# ACCESSIBILITY ASSESSMENT

## ADA TITLE II ASSESSMENT

UNC Ackland Art Museum

*July 10, 2024*

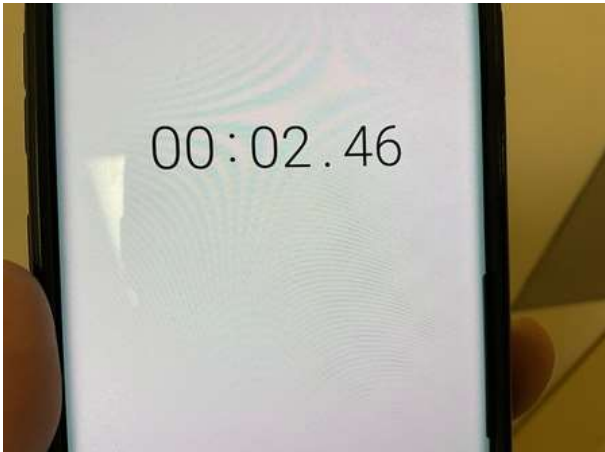
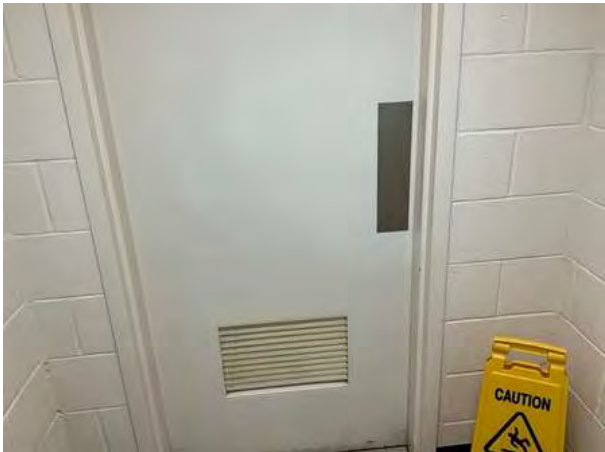
The accessible door with door closer has a sweep period of less than 5 seconds from 90 degrees to a position 12 degrees from latch.

The outer door takes 2.39 seconds the inner door takes 2.46 seconds to close from 90° to 12° off the door jam.

Adjust closer or remove and replace closer to ensure that the door has a closure time of at least 5 seconds within 12 degrees of the latch. To be completed with ID: AX456246. Door closers and gate closers shall be adjusted so that from an open position of 90 degrees, the time required to move the door to a position of 12 degrees from the latch is 5 seconds minimum.

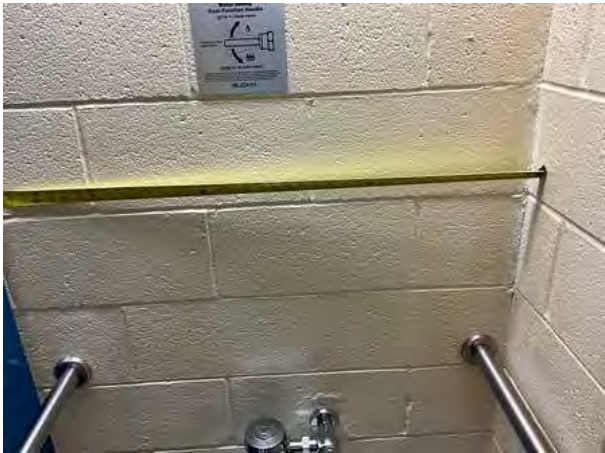
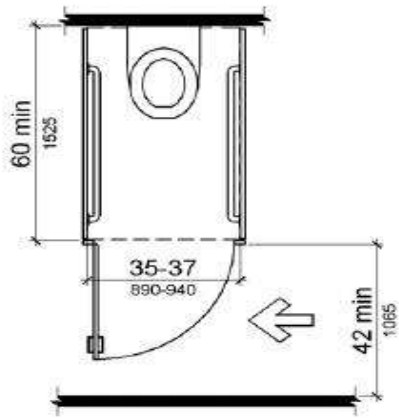
Location Description	Basement Women's Restroom
----------------------	---------------------------

Site Conditions	The ambulatory stall is 39 1/2 inches wide by 72 1/2 inches deep
-----------------	--

Provide a compliant ambulatory stall, where six or more toilet compartments are provided or where the combination of urinals and water closets totals six or more fixtures. An ambulatory stall is minimum 60" deep and the width is minimum 35" and maximum 37". Grab bars shall be provided on both sides of the compartment. The side grab bars shall be 33" minimum to 36" maximum above finish floor to the top of the gripping surface, except in children's (ages 3-12) water closets where horizontal grab bars shall be 18" minimum and 27" maximum above the finish floor to the top of the gripping surface. Horizontal grab bars should be installed at a consistent height. The side wall grab bars shall be 42" long minimum, located 12" maximum from the rear wall and extending 54" minimum from the rear wall. The centerline of the toilet shall be minimum 17" to maximum 19" from the side wall. Toilet compartment doors for ambulatory stalls shall be minimum 32" wide when open 90 degrees and have minimum 80" high clearance. If the approach is to the latch side of the compartment door, clearance between the exterior side of the door of the compartment and any obstruction shall be 42" minimum. The door shall be self-closing. A compliant door pull shall be placed on both sides of the door near the latch. Toilet compartment doors shall not swing into the minimum required compartment area. [ADVISORY: It is advisable, but not required, to use the specifications for children where children are the primary users of the restroom. Guidance in applying the specifications for children according to the age group served reflects the differences in the size, stature, and reach ranges of children ages 3 to 12. The specifications chosen should correspond to the age of the primary user group. The specifications of one age group should be applied consistently in the installation of a water closet and related elements. Water Closet Centerline: Ages 3 and 4- 12"; Ages 5 through 8- 12" to 15"; Ages 9 through 12- 15" to 18". Toilet Seat Height: Ages 3 and 4- 11" to 12"; Ages 5 through 8- 12" to 15"; Ages 9 through 12- 15" to 17". Grab Bar Height: Ages 3 and 4- 18" to 20"; Ages 5 through 8- 20" to 25"; Ages 9 through 12- 25" to 27"; Dispenser Height: Ages 3 and 4- 14"; Ages 5 through 8- 14" to 17"; Ages 9 through 12- 17" to 19".]

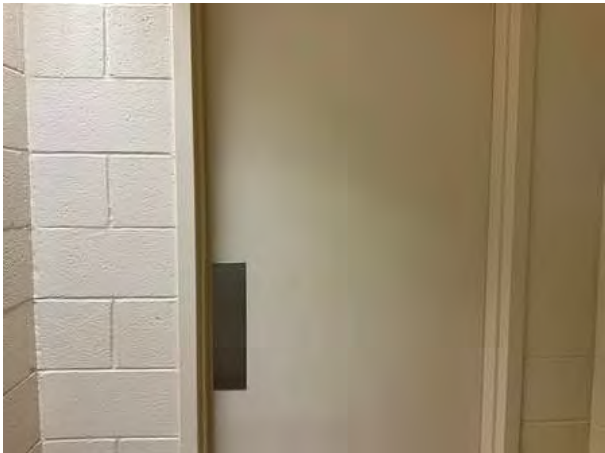
The outer restroom door takes 10 pounds of pressure to open the inner restroom door takes 17 pounds pressure to open.

Adjust closer or replace with an closer that requires no more 5 pounds of force to stop the door motion. o be completed along with ID: AX456235. The maximum force for pushing or pulling open a door shall be for interior hinged doors: 5 lbs (22.2N). The force for pushing or pulling open a door or gate other than fire doors shall be as follows: 1. Interior hinged doors and gates: 5 pounds (22.2 N) maximum. 2. Sliding or folding doors: 5 pounds (22.2 N) maximum. These forces do not apply to the force required to retract latch bolts or disengage other devices that hold the door or gate in a closed position. Note: Fire doors shall have a minimum opening force allowable by the appropriate administrative authority.

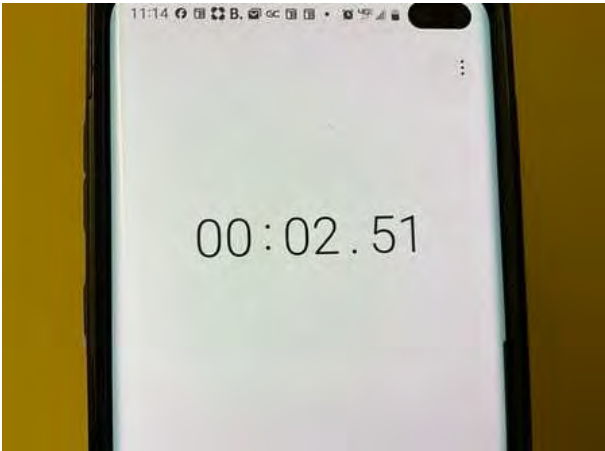
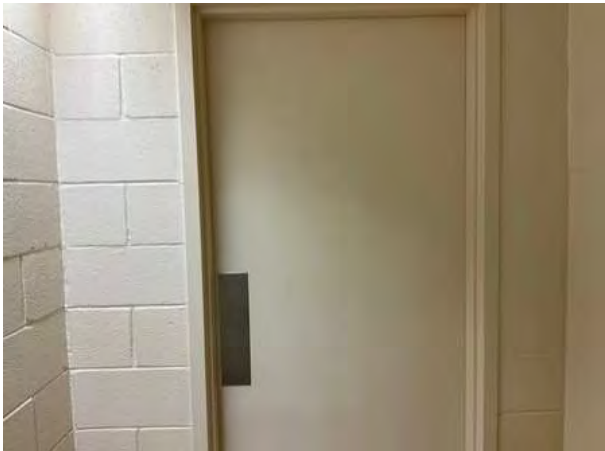
The accessible door with door closer has a sweep period of less than 5 seconds from 90 degrees to a position 12 degrees from latch.

Location Description	Basement Women's Restroom
Observed	May 21, 2024 by Brian.rogers@bureauveritas.com
Site Conditions	The inner door takes 2.51 seconds to close from 90° to 12° off the door jam.

Adjust closer or remove and replace closer to ensure that the door has a closure time of at least 5 seconds within 12 degrees of the latch. To be completed along with ID: AX456234. Door closers and gate closers shall be adjusted so that from an open position of 90 degrees, the time required to move the door to a position of 12 degrees from the latch is 5 seconds minimum.

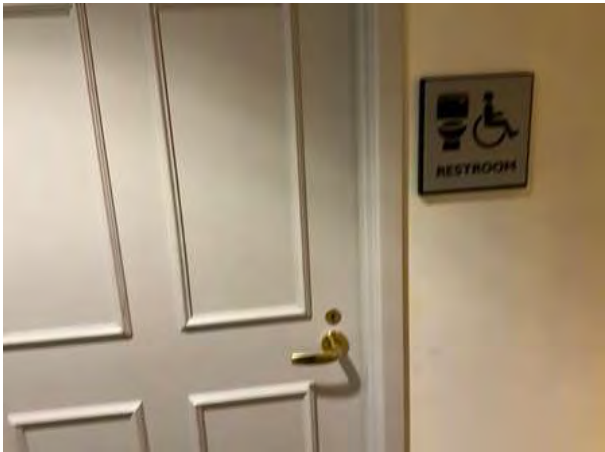
Assembly	Restroom
Type	Restroom/Bathroom - Door
ADA Standard	404.2.9
Barrier Detail	
The force required to open the interior, hinged, non-fire door is more than 5 pounds.	
Location Description	First Floor accessible unisex Restroom
Observed	May 22, 2024 by Brian.rogers@bureauveritas.com
Site Conditions	The unisex restroom door takes 10 pounds of pressure to open.

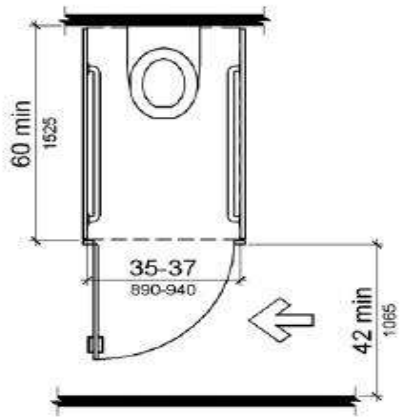
<b>Assembly</b>	Restroom
<b>Type</b>	Restroom/Bathroom - Ambulatory Stall
<b>ADA Standard</b>	213.3.1, 309, 404.2.7, 604.8.2
<b>Barrier Detail</b>	
The ambulatory stall size is not compliant, or an ambulatory stall is not provided.	
<b>Location Description</b>	First Floor Men's Restroom
<b>Observed</b>	May 21, 2024 by Brian.rogers@bureauveritas.com
<b>Site Conditions</b>	The ambulatory stall is 40 inches wide by 70 inches deep.

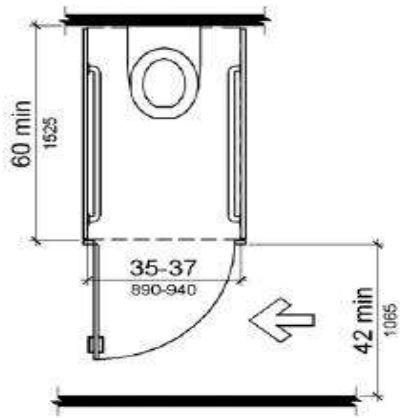
<b>Assembly</b>	Restroom
<b>Type</b>	Restroom/Bathroom - Ambulatory Stall
<b>ADA Standard</b>	213.3.1, 309, 404.2.7, 604.8.2
<b>Barrier Detail</b>	
The ambulatory stall size is not compliant, or an ambulatory stall is not provided.	
<b>Location Description</b>	First Floor Women's Restroom
<b>Observed</b>	May 21, 2024 by Brian.rogers@bureauveritas.com
<b>Site Conditions</b>	The ambulatory stall is 40 inches wide by 70 1/2 inches deep.

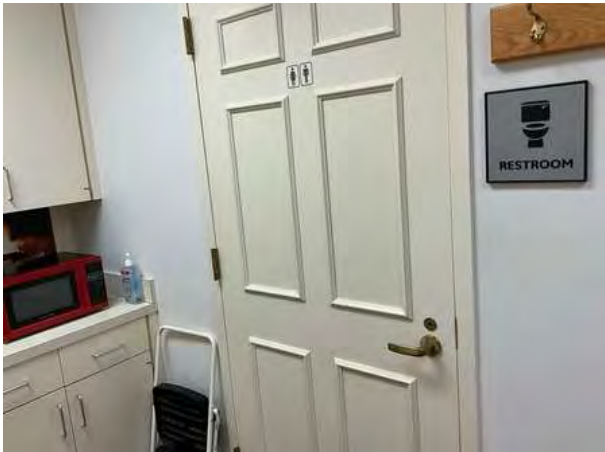
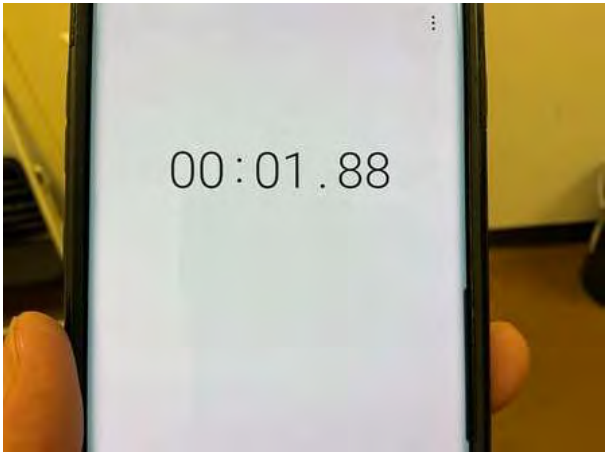
Unisex Restroom A has a closing speed of 2.78 seconds unisex restroom B has a closing speed of 1.88 seconds from 90 degrees to 12 degrees from the door jam.

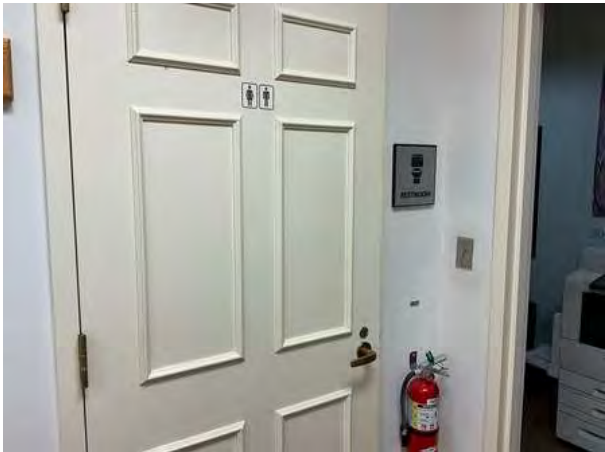
Assembly	Restroom	
Type	Restroom/Bathroom - Signage	
ADA Standard	216.2, 703.1, 703.2, 703.5, 703.6	
Barrier Detail		
The restroom does not have compliant signage at the door with the International Symbol of Accessibility, raised characters, and Braille.		
Location Description	Second Floor Unisex A and B	
Observed	May 22, 2024 by Brian.rogers@bureauveritas.com	
Site Conditions	The 2 restroom signs do not have the international symbol of accessibility.	
Resolution		
Mount compliant signage on the wall at the latch side of the restroom door at a compliant height. All signs for accessible restrooms, including directional signs indicating the restroom location, shall comply with the requirement for the International Symbol of Accessibility (ISA), where not all restrooms are accessible. The pictogram field shall be minimum 6" high. Signage shall include raised letters and Braille, either one sign with both visual and tactile characters, or two separate signs, one with visual, and one with tactile characters, shall be provided. Tactile characters on signs shall be located 48" minimum above the finish floor or ground surface, measured from the baseline of the lowest tactile character and 60" maximum above the finish floor or ground surface, measured from the baseline of the highest tactile character. Accessible restrooms shall have signs with the International Symbol of Accessibility. Where a tactile sign is provided at a door, the sign shall be located alongside the door at the latch side. Where a tactile sign is provided at double doors with one active leaf, the sign shall be located on the inactive leaf. Where a tactile sign is provided at double doors with two active leafs, the sign shall be located to the right of the right hand door. Where there is no wall space at the latch side of a single door or at the right side of double doors, signs shall be located on the nearest adjacent wall. Signs containing tactile characters shall be located so that a clear floor space of 18" minimum by 18" minimum, centered on the tactile characters, is provided beyond the arc of any door swing between the closed position and 45 degree open position. [EXCEPTION: Signs with tactile characters shall be permitted on the push side of doors with closers and without hold-open devices.] Raised characters shall be as follows: Depth: Raised characters shall be 1/32" minimum above their background. Case: Characters shall be uppercase. Style: Characters shall be sans serif. Characters shall not be italic, oblique, script, highly decorative, or of other unusual forms. Character Proportions: Characters shall be selected from fonts where the width of the uppercase letter "O" is 55 % minimum and 110 % maximum of the height of the uppercase letter "I". Character Height: Character height measured vertically from the baseline of the character shall be 5/8" minimum and 2" maximum based on the height of the uppercase letter "I". [EXCEPTION: Where separate raised and visual characters with the same information are provided, raised character height shall be permitted to be 1/2" minimum.] The visual characters of the sign shall be installed at minimum 40" above finish floor.
